Wisconsin Department of Transportation

Letting of October 11, 2022

This is Addendum No. 03, which provides for the following:

ADDENDUM NO. 03

Addendum No. 03
 ID 1229-04-71/72/73/77
 Revised Sheet 2973
 October 6, 2022

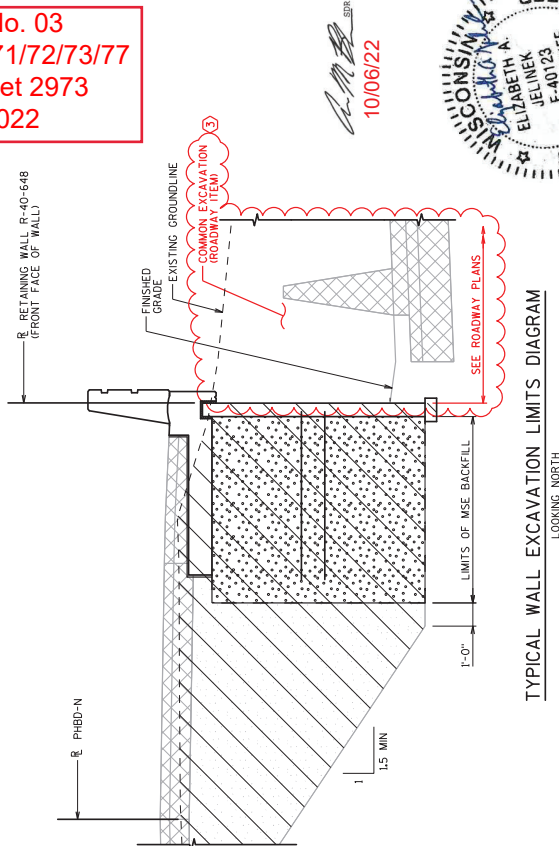
Revised Plan Sheets	
Plan Sheet	Plan Sheet Title (brief description of changes to sheet)
1665	Miscellaneous Quantities – 1229-04-72 Earthwork Table Updated
1701	Miscellaneous Quantities – Updated Breaker Run Quantity
2869	Structures – Revised Typical Wall Excavation Limits Diagram
2881	Structures – Revised notes in Elevation View
2884	Structures – Revised Quantity Table
2917	Structures – Revised Quantity Table
2973	Structures – Revised Typical Wall Excavation Limits Diagram

NO.	DATE	REVISION	BY
3	10/9/22	EXCAVATION UPDATES	EJA
